Falmouth Docks Development: Appropriate Assessment Addendum – Fal and Helford SAC

Project name **Falmouth Docks Development**
Project no. **1620015743-006**
Client **A&P Group**

Date 13/10/2025

This AA Addendum addresses the following specific points raised by Natural England regarding detailed advice (Ref: 519879, 08 September 2025) on the HRA for impacts to support a conclusion of no Adverse Effect on Integrity (AEoI) on the Fal and Helford SAC:

Figure 16 - Sediment deposition (mm) overlain on maerl habitat classification at the end of the entire dredging campaign as a result of proposed dredging operations (Carcinus Ltd, 2025)

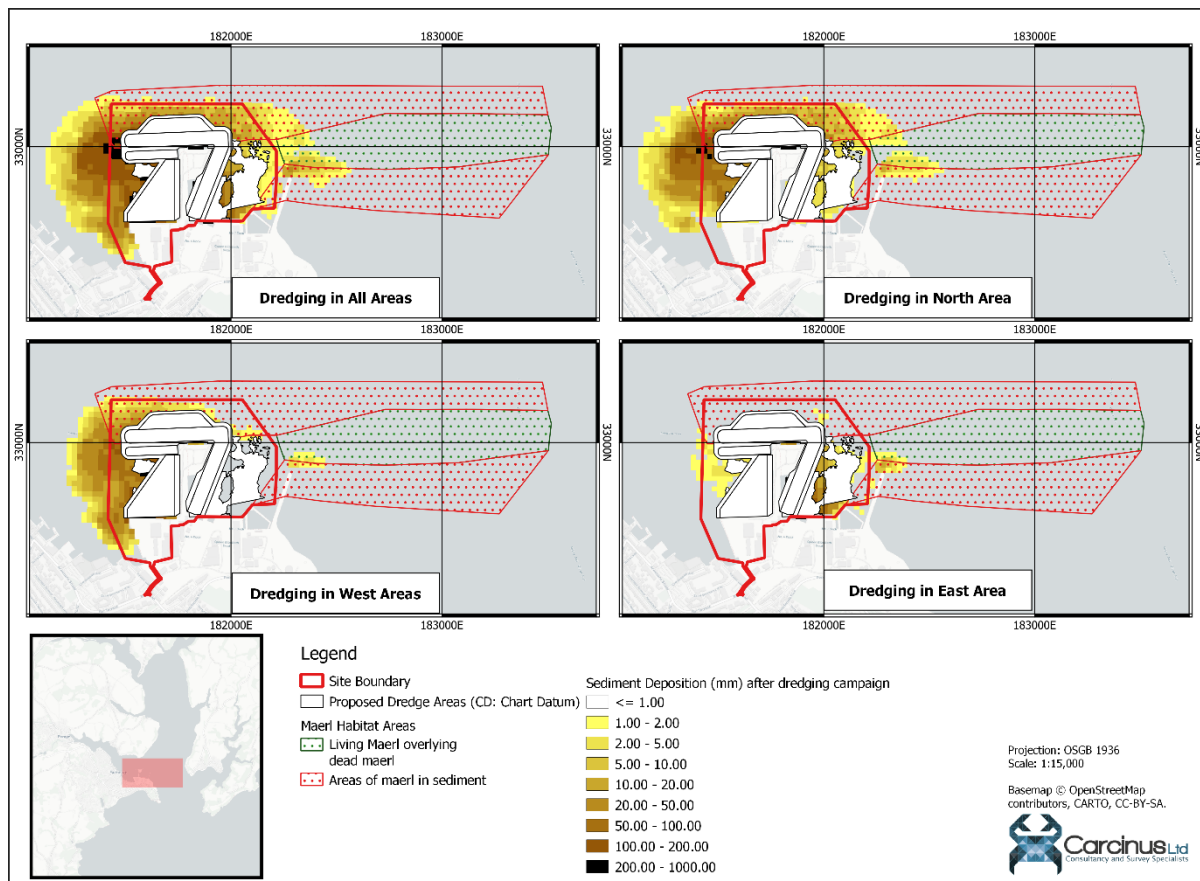
Deposition modelling following dredge activities, when overlaid as contour plots on maerl habitat mapping demonstrates that the area of deposition is largely constrained to the red line boundary, with a very limited spatial ZOI (Figure 16).

The area of deposition outside the eastern site boundary, extends to areas mapped as live maerl over dead maerl. The maximum deposition value within this habitat of 18.4 mm sediment depth was extracted from the contour plot. The higher values reported, of 50 mm, were also based on contour plot data, predicted for a localised area at the end of the Eastern Breakwater. This is outside the area with live maerl, instead within the habitat mapped as maerl in sediment but identified as dead maerl with a 2D structure (see Figure 6). HR Wallingford have estimated the area of total deposition predicted by the modelling within the areas mapped as live maerl overlying dead maerl. Approximately 1.38 ha of this area is modelled as having a total deposition of 1-2 mm; approximately 0.96 ha is modelled as having a total deposition of 2-5 mm; approximately 0.71 ha is modelled as having a total deposition of 5-10 mm; and approximately 0.04 ha is modelled as having a total deposition of 10-20 mm.

Figure 17 - Predicted time-averaged concentration of Tributyl tin (TBT) over 15 days of dredging

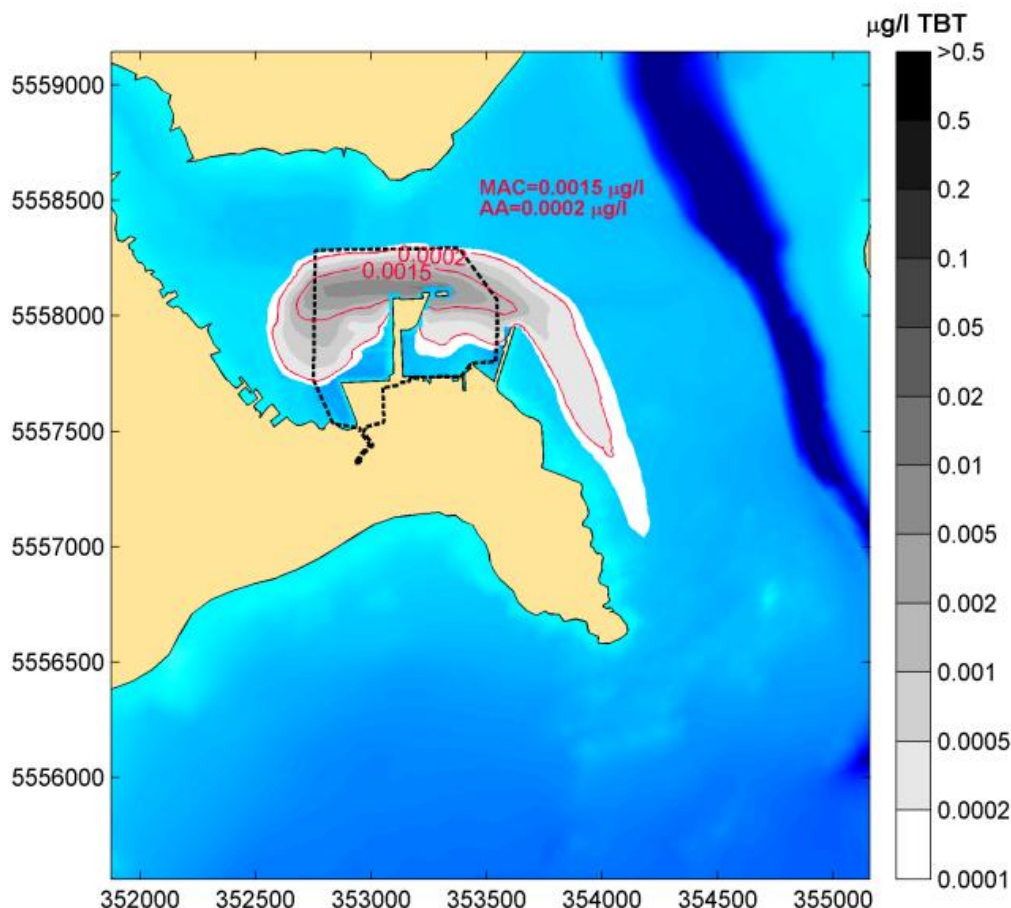
When reviewing specific contaminants that would be released as part of the proposed dredge activity, TBT is the only contaminant released into the aqueous phase that was modelled to be present in concentrations above EQS standards (Figure 17). Note, the modelling undertaken was for the unmitigated scenario only, with dredging during any tidal condition.

However, as stated in the HRA Report, the inclusion of the tidal mitigation for dredge activities is predicted to halve the concentration of TBT in aqueous phase. The concentration of the predicted 'finger' of aqueous contamination extending southeast of the site boundary would be halved and if remapped would be significantly reduced in extent.

Thus, the proposed mitigation also constrains the ZOI in relation to contamination of TBT in the water column to be largely contained within the red line boundary. Cefas have reviewed the ES and the Technical Appendices and were satisfied with the approach taken and conclusions of no significant impacts to benthic features.
